# Access Compliance Report

## Public Rights-of-Way

Intersection ID: 10039270	Main Street: SUNSET_RD	Cross Street: N/A	Location: S
ADA ID: 9B2217A58410	Ramp Type: Para	Initial Pass/Fail: Pass	Overall Compliance: No
			Severity Score: 5

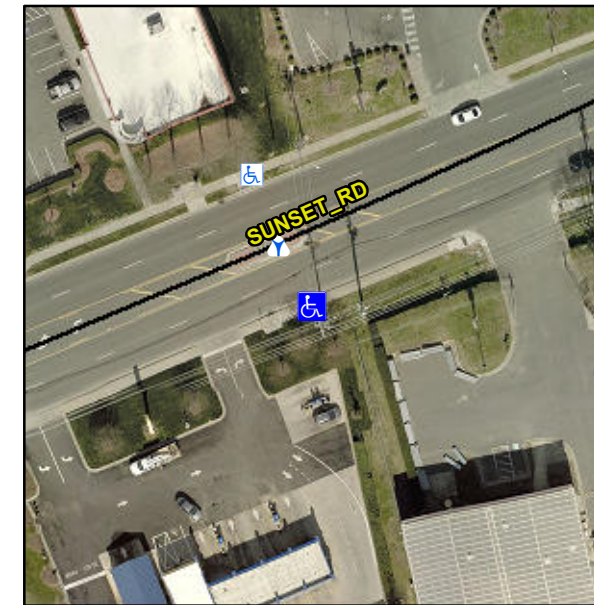
**Not Found, R304.5.4**

Compliance	Description	Data	Compliance	Description	Data
N/A	Ramp Length LT (in)	78.0	N/A	Ramp Length RT (in)	76.0
Yes	Ramp Width LT (in)	60.0	Yes	Ramp Width RT (in)	60.0
Yes	Ramp Slope LT (%)	7.6	Yes	Ramp Slope RT (%)	7.7
Yes	Ramp XSlope LT (%)	0.9	Yes	Ramp XSlope RT (%)	0.9
Yes	Landing Length (in)	60.0	Yes	DWS Provided?	Yes
Yes	Landing Width (in)	48.0	Yes	DWS Contrast?	Yes
Yes	Landing Slope (%)	0.9	Yes	DWS Length (in)	24.0
Yes	Landing X Slope (%)	0.2	Yes	DWS Full Width?	Yes
N/A	Landing Curb? (Y/N)	Yes	Yes	DWS Offset (in)	0.0
N/A	Shared Landing?	No			
Yes	Gutter Ponding?	No	No	Gutter Slope (%)	8.8
Yes	Gutter Lip Ht (in)	0.0	Yes	Gutter X Slope (%)	1.5
N/A	Painted X Walk1?	No	N/A	Painted X Walk2?	N/A
	X Walk 1 Direction	To NW		X Walk 2 Direction	N/A
N/A	X Walk 1 Width (in)	N/A	N/A	X Walk 2 Width (in)	N/A
	X Walk 1 Slope (%)	2.0		X Walk 2 Slope (%)	N/A
	X Walk 1 X Slope (%)	1.4		X Walk 2 X Slope (%)	N/A
N/A	Ramp inside XWalk1?	N/A	N/A	Ramp inside XWalk2?	N/A

Road Slope (%)	N/A	N/A	Clear Space?	Yes
	Road X Slope (%)	N/A	N/A	Clear Space to XWalk (in)	N/A
Yes	Any Obstructions?	No	Yes	Storm Grate/Utility Hazard?	No
	Obstruction Type			Storm Grate/Utility Type	
			N/A		N/A
			Yes	Surface Condition? (G/P)	Good
				Replace Curb Slope (%)	9.1

**Remove & Replace Entire Ramp.  
Remove & Replace Gutter.**
